Subject: Grand Gulf Nuclear Station  
Docket No. 50-416  
License No. NPF-29  
Partial Response to Containment Systems and  
Severe Accident Branch Request for Additional  
Information Concerning Request for Exemption  
from 10CFR Part 50, Appendix J

GNRO-94/ 00077

FINAL RESPONSE TO CONTAINMENT SYSTEMS AND  
SEVERE ACCIDENT BRANCH  
REQUEST FOR ADDITIONAL INFORMATION  
CONCERNING REQUEST FOR EXEMPTION FROM  
10CFR PART 50, APPENDIX J  
GRAND GULF NUCLEAR STATION  
DOCKET NO. 50-416

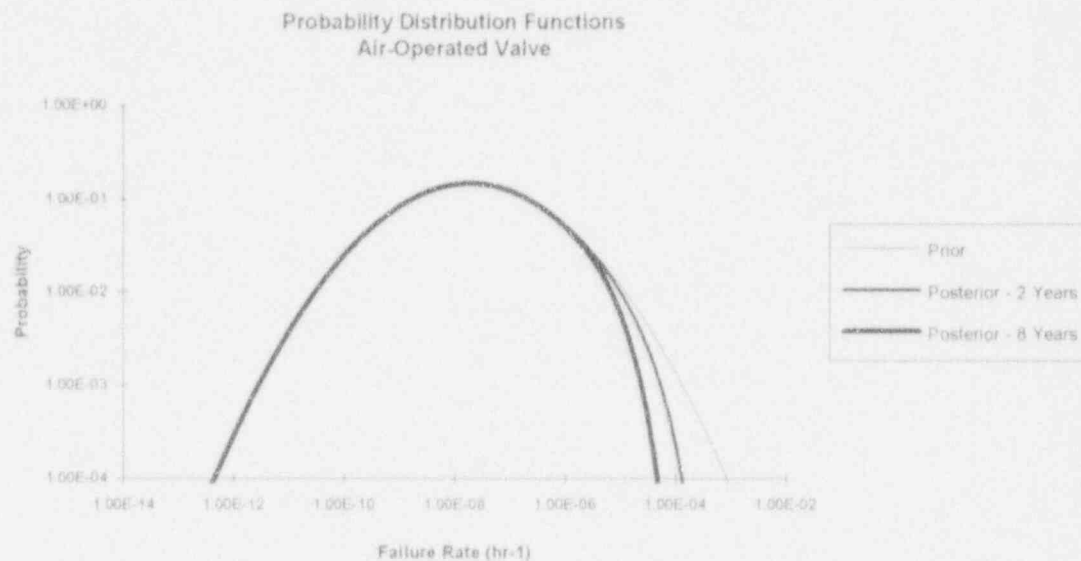
4. In generating Figure 2-1, Isolation Valve Failure Rate Estimates, generic component failure rates are again used. The decreasing component failure rate over time is based on no observed failures of the component over time. The calculation ignores any component failures which may have occurred prior to the time "0". It appears that once a component undergoes maintenance, it is assumed to be "as good as new". The reliability of a component would be expected to be both a function of the nature of the component as well as its environment. The environmental aspect as measured by the component performance history does not appear to be considered. If a specific component fails frequently, a higher rather than a decreasing failure rate for the particular component is expected. This should be reflected in the Bayesian analysis.

Figure 2-1 of the application shows only the calculated mean values of the failure rates as functions of time. The following figure shows the prior and posterior distributions after 2 years and after 8 years for one valve type. The qualitative result is that the mean value decreases with time and that the spread in the distribution becomes narrower. The low failure rate end of the distribution is essentially unchanged. The high end of the distribution becomes cut off as time increases. This has the effect of pushing the mean to lower values. Since the principal use of the Bayesian analysis is to support the concept of a variable testing schedule based on component performance, the spreads in the prior and posterior distributions were not included in the application.

The curves shown in Figure 2-1 are indeed for hypothetical components put into service at time zero that experience no subsequent failures with time. The figures are not intended to encompass every case. They do not include every valve combination, nor do they include combinations of valves which may have experienced failures at some point during their service life.

A Bayesian analysis of valves which experience failures (either due to environmental effects or due to other causes) would potentially result in higher calculated failure rates. Entergy does not propose to establish testing schedules based on Bayesian analysis of individual valves or penetrations, however. The proposed testing program incorporates a more straightforward algorithm to determine the testing schedule. The program will identify potential poor performers and retain them on the current two-year testing schedule.

Again, the intention of the Bayesian analysis is only to illustrate that the concept of a variable testing schedule is consistent with demonstrated past good performance.
